Our ref: 24SYD9608

**RE: Addendum to Bushfire Protection Assessment – Proposed Residential Subdivision
412 Cessnock Road, Gillieston Heights**

This report is an addendum to the bushfire protection assessment (BPA) prepared by Eco Logical Australia (ELA) 20 June 2022 (ELA 2022; 21SYD_20059 version 1) to support a modification application of 412-414 Cessnock Road, Gillieston Heights.

Figure 1: Updated Subdivision Layout

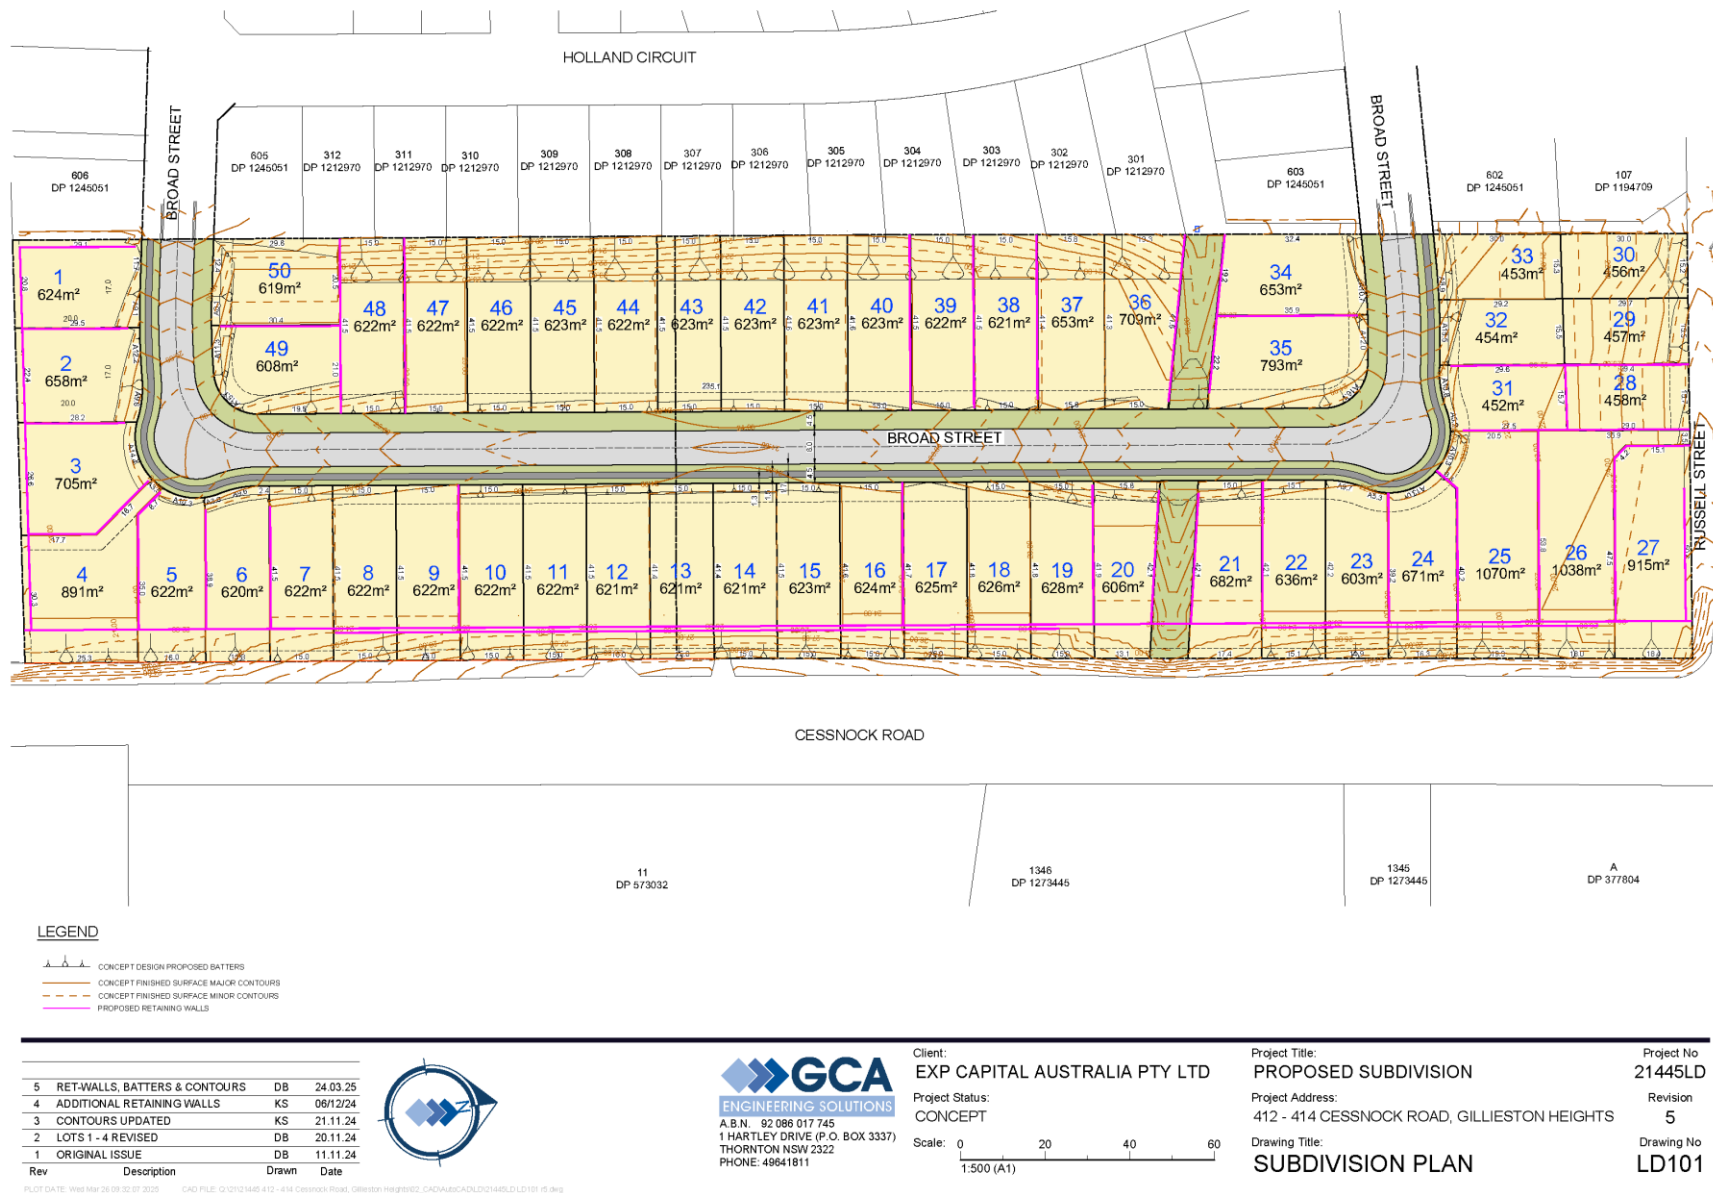
Maitland City Council issued a Notice of Determination (NOD) dated 17 January 2024 (DA/2022/783) which includes the RFS General Terms of Approval (Appendix A), approving the proposed subdivision. EXP Capital are now seeking a Section 4.55 (2) [Modification involving minimal environmental impact] addressing the modifications to the subdivision design (Figure 1). This will result in a reduction of lots from 59 to 50 lots.

Figure 3: Bushfire Hazard Assessment of Modified Concept

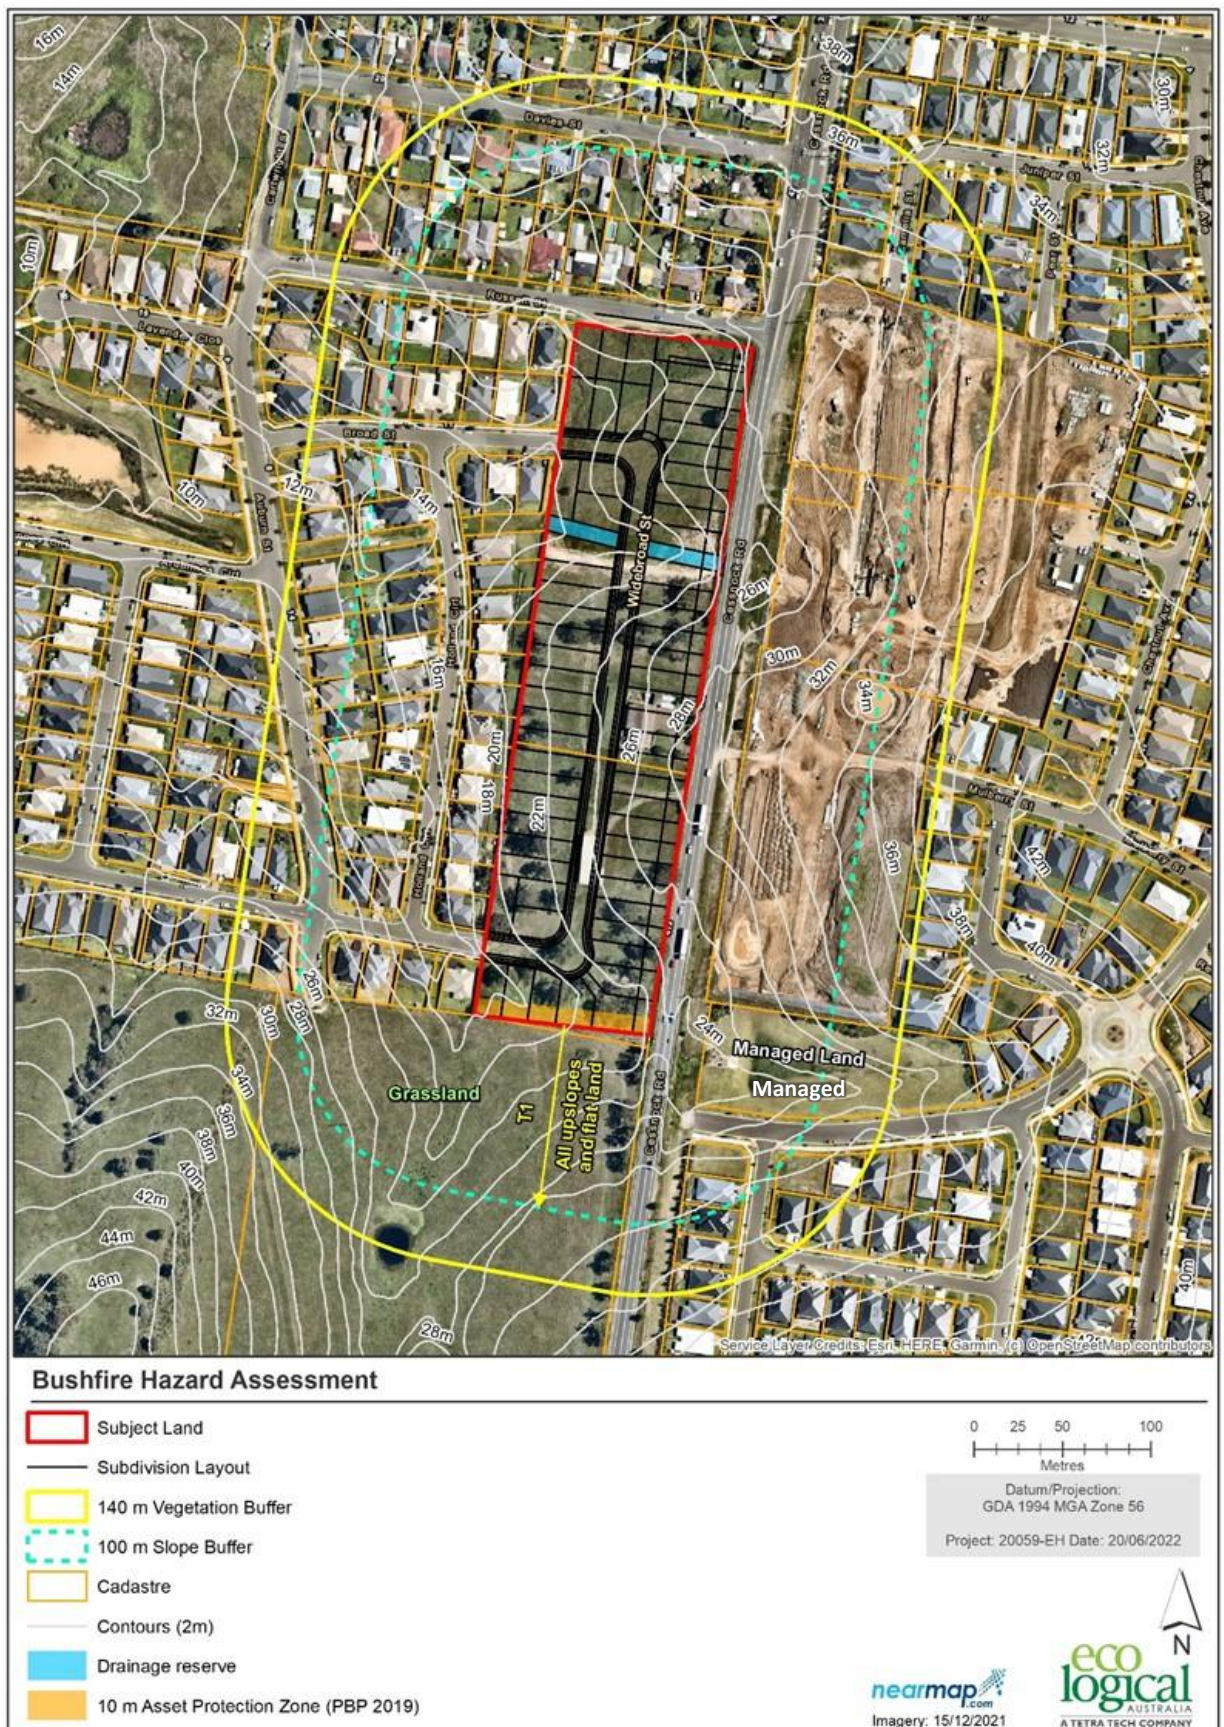
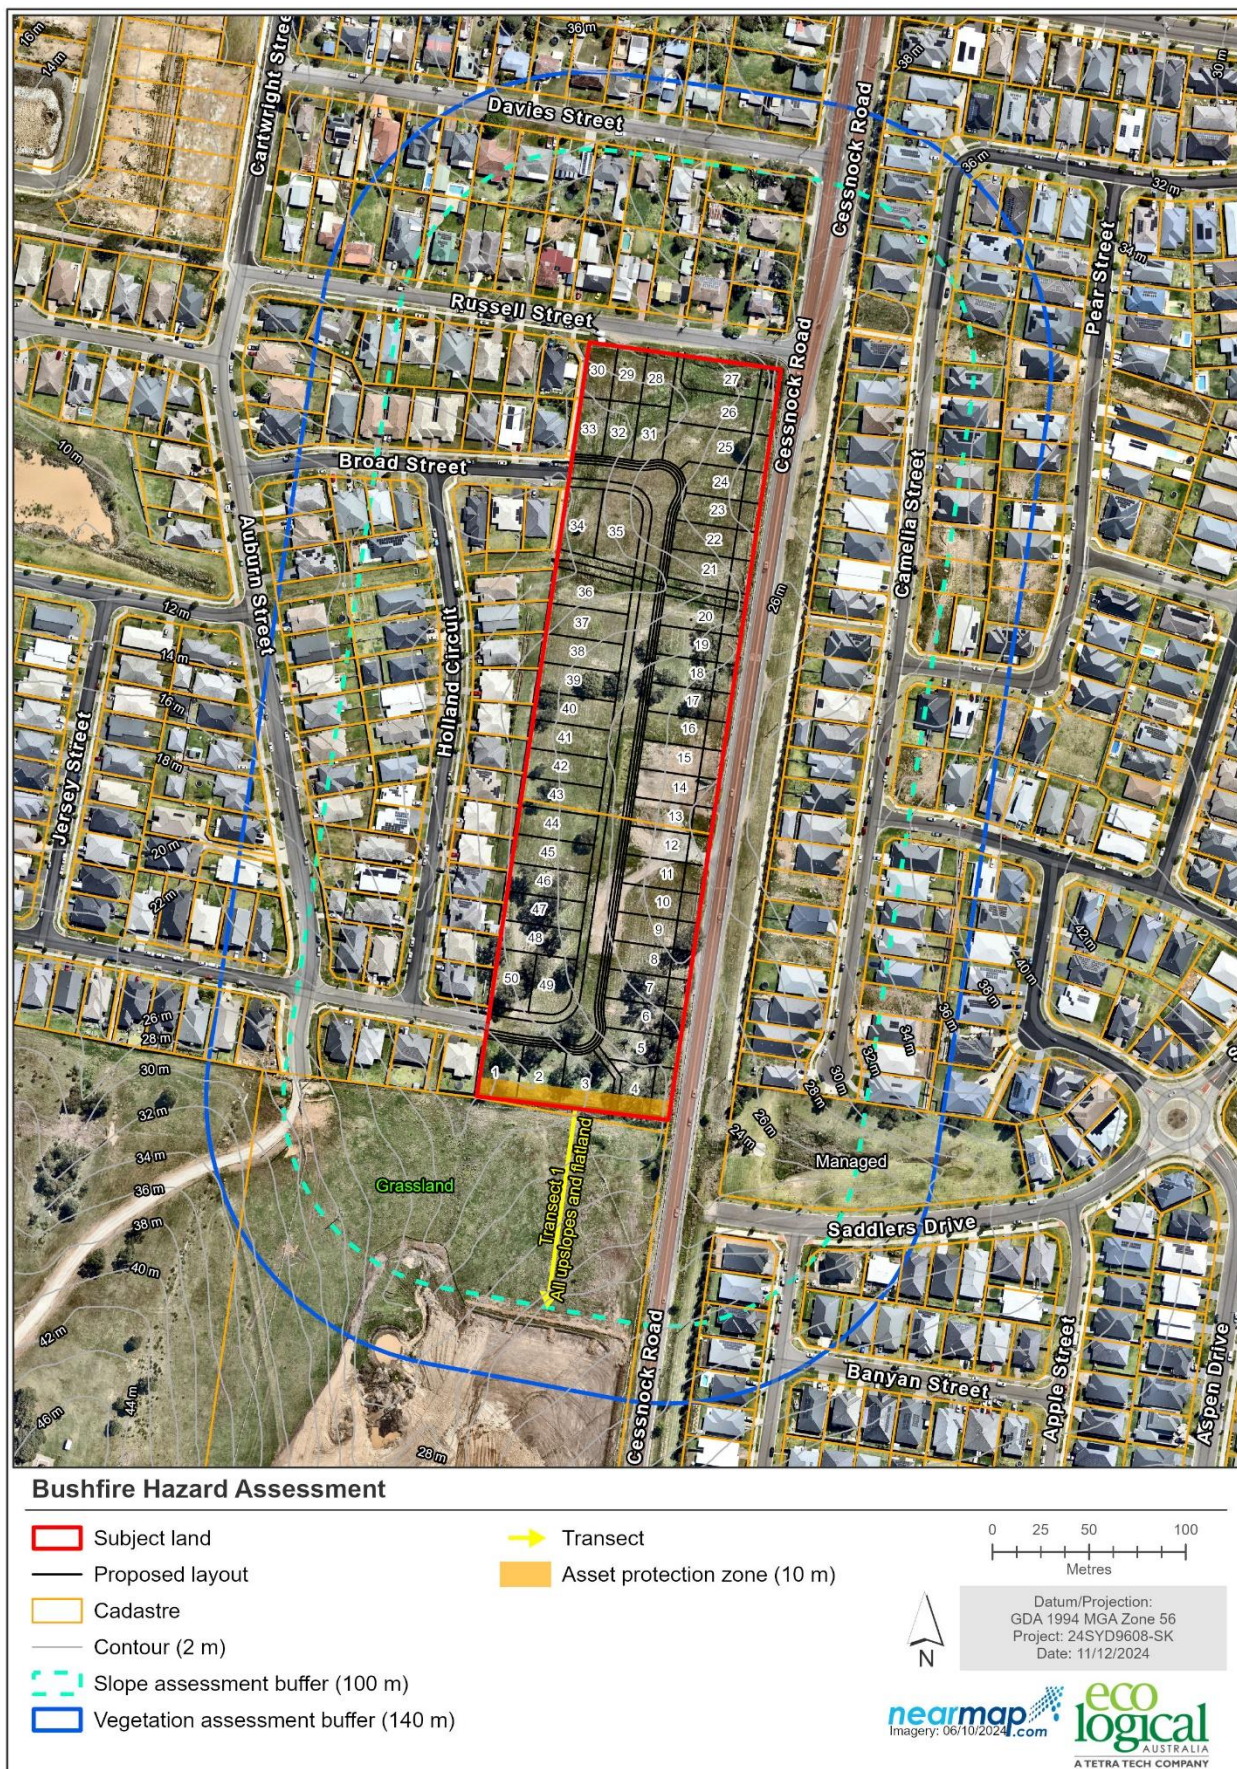
All bushfire protection measures (BPM) assessed within the previous bushfire protection assessment (ELA 2022) remain unchanged i.e. Asset Protection Zones (APZ) widths, access, water and electricity. Figure 2 shows the previous bushfire hazard assessment and Figure 3 shows that the hazard assessment remains unchanged with the latest concept design.
